# ENVIRONMENTAL REVIEW TEAM REPORT

**Madison Hills  
Development  
Madison,  
Connecticut**

Madison Planning and Zoning Commission

JANUARY 1987

Figure 2

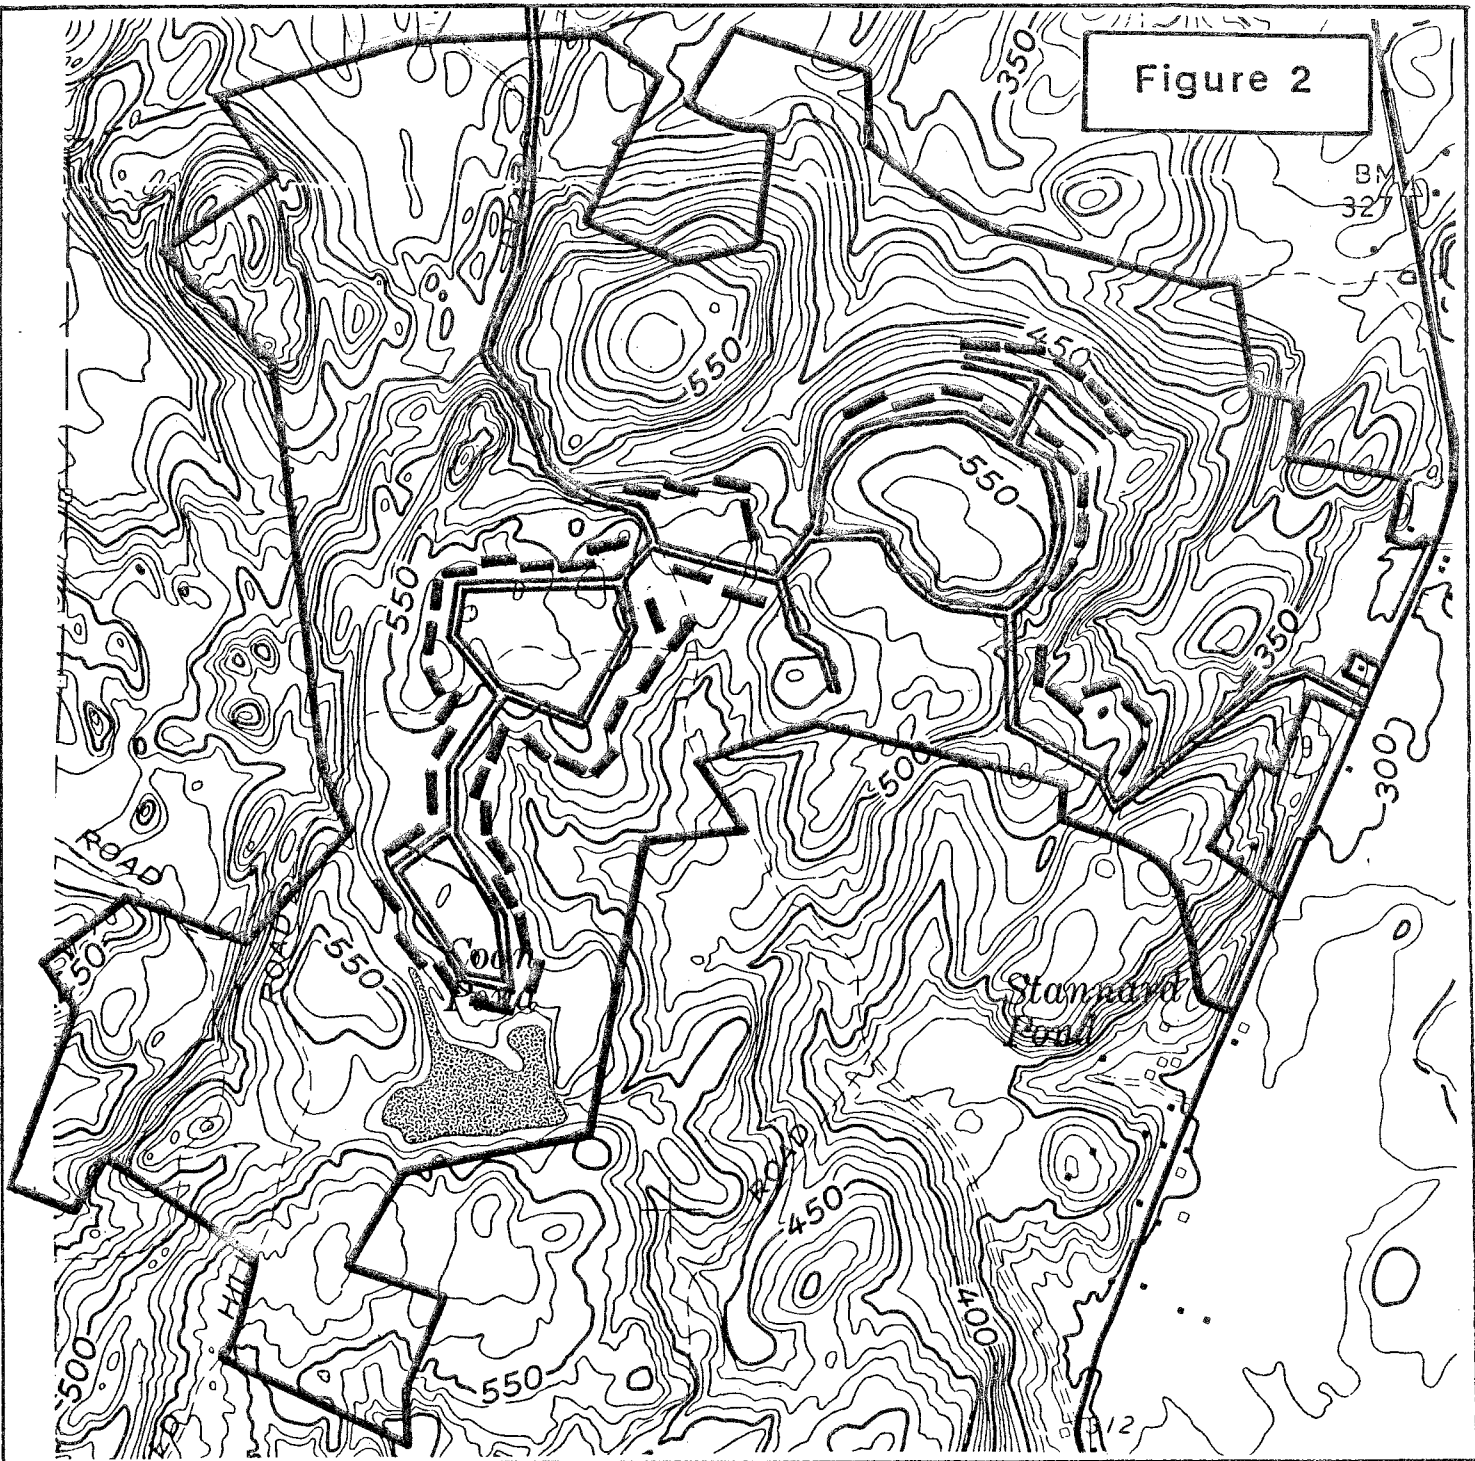
The preliminary cluster proposal shows building orientation along the contours of the hills on this property. Access roadways likewise conform to the existing contours.

Soil erosion and sediment control planning will still be intensive and require complex measures to protect both the steeply sloping uplands and the adjacent wetland areas.

Figure 2A

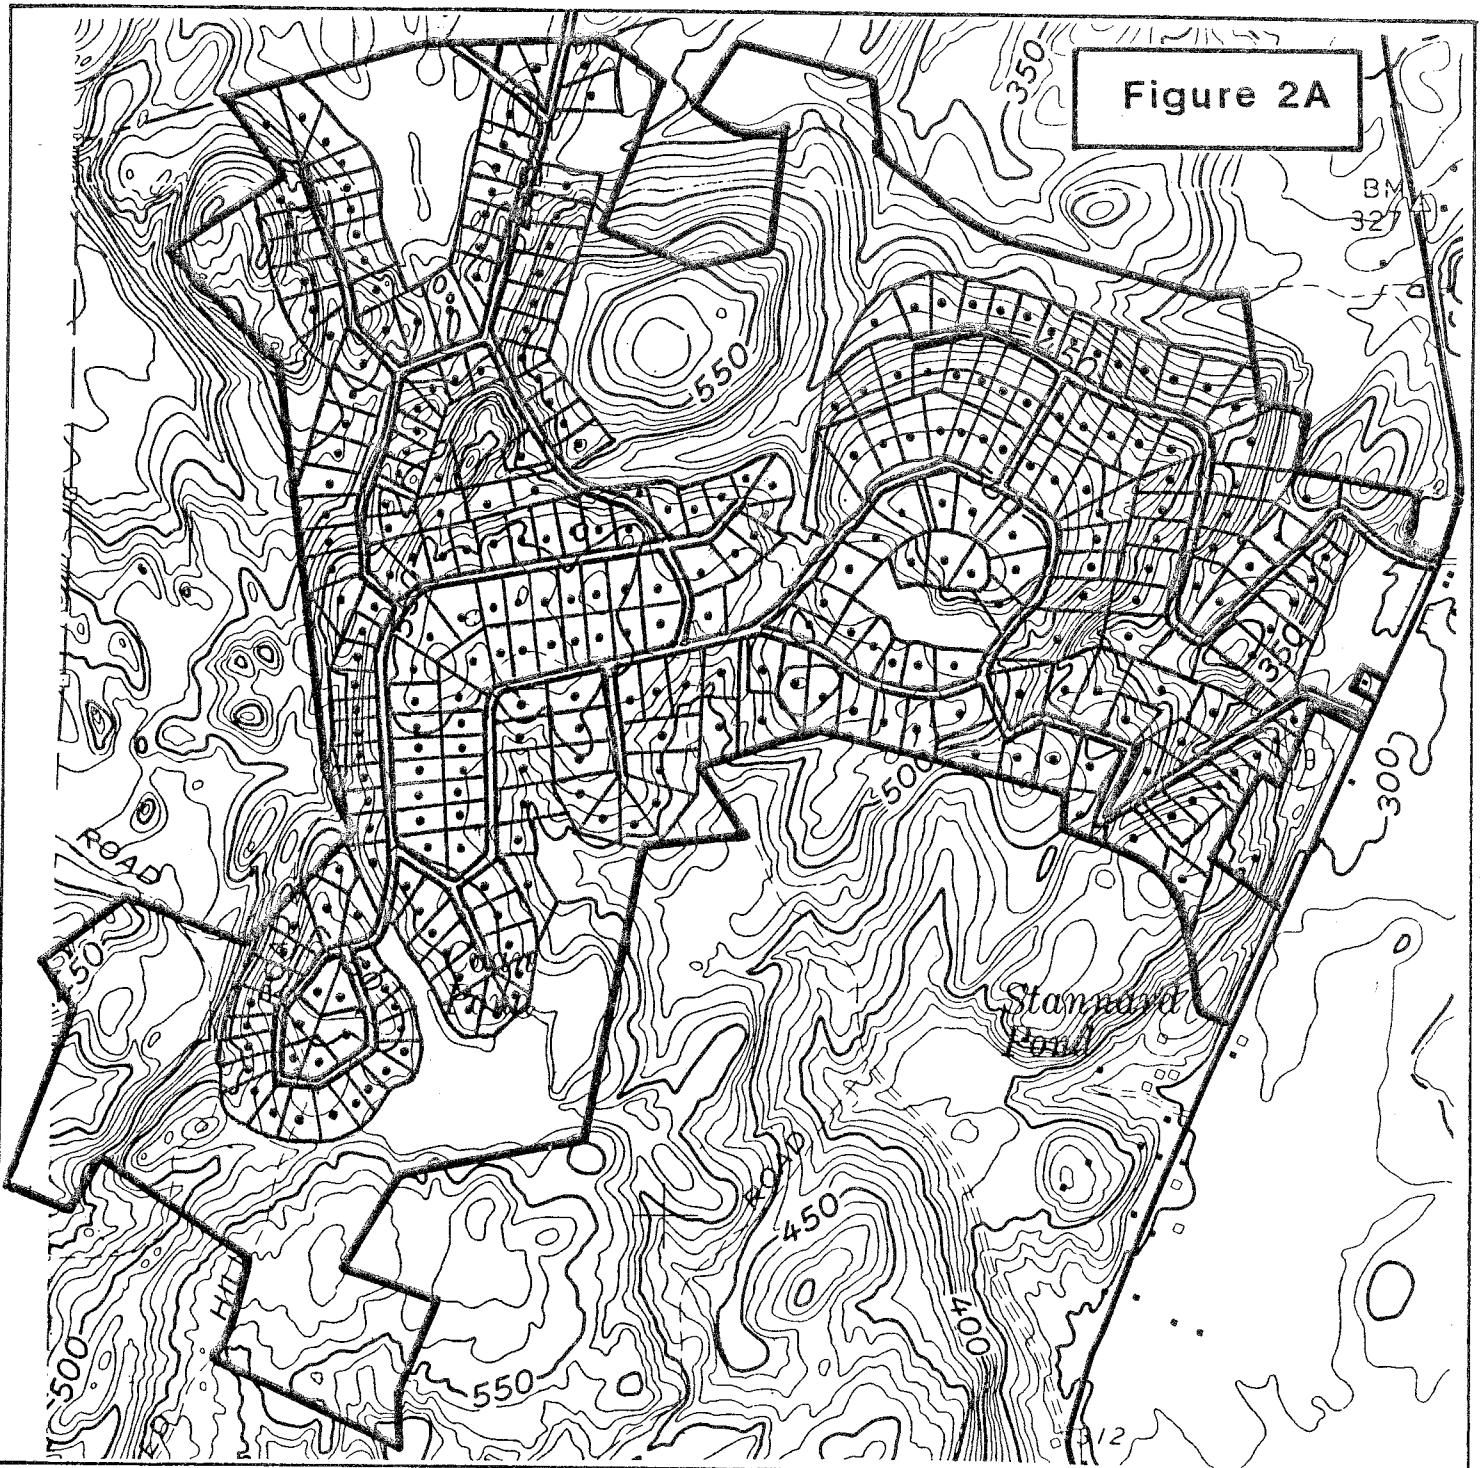
The preliminary single-family subdivision plan shows a very dense lot layout especially in steeply sloping areas with slopes of 25 percent and greater. Lot layouts do not follow the existing ground contour. Many of the lots will require extremely intensive and complex erosion and sediment control

measures to protect adjoining properties from serious off-site sedimentation problems.

Figure 6

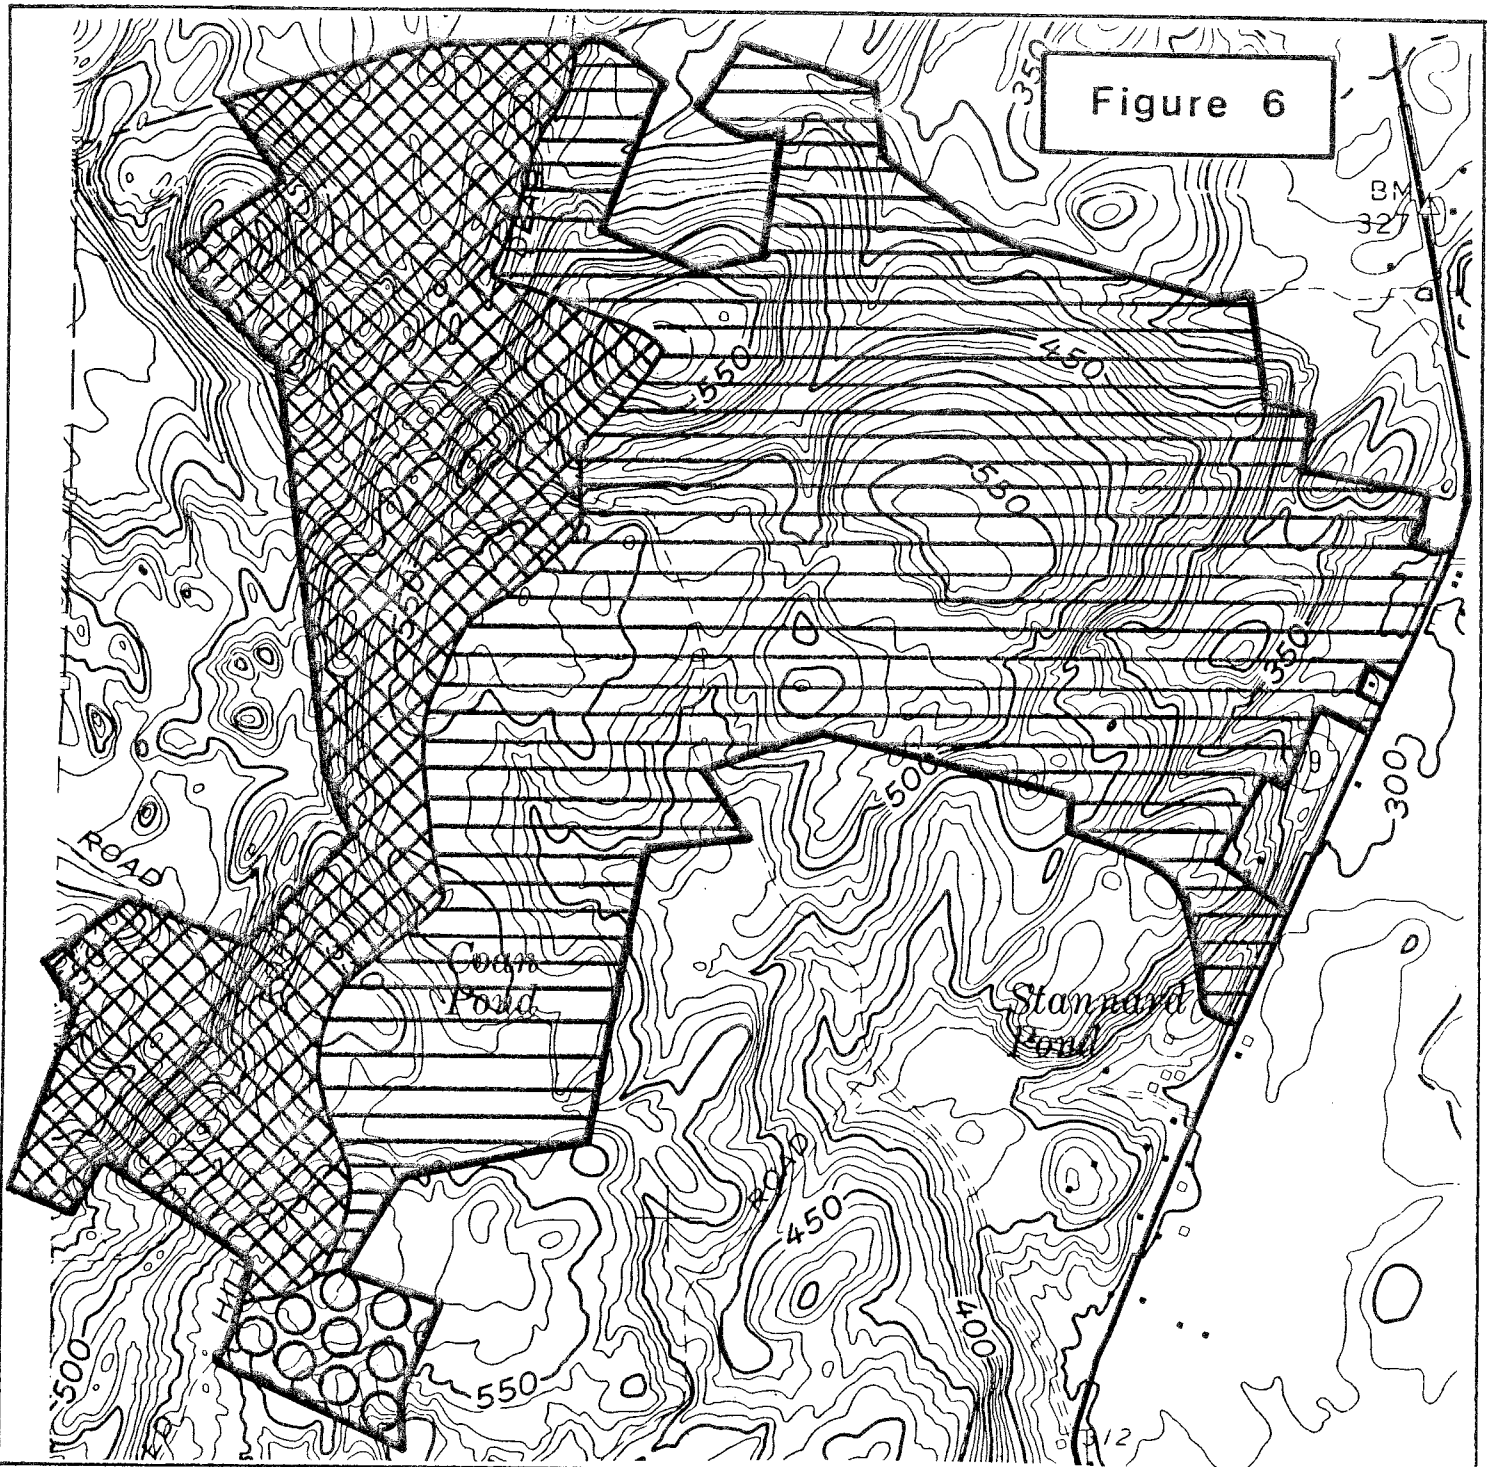
A small, southern part of the site drains southward through a series of small wetlands and is ultimately routed to Stony Brook (Figure 6).
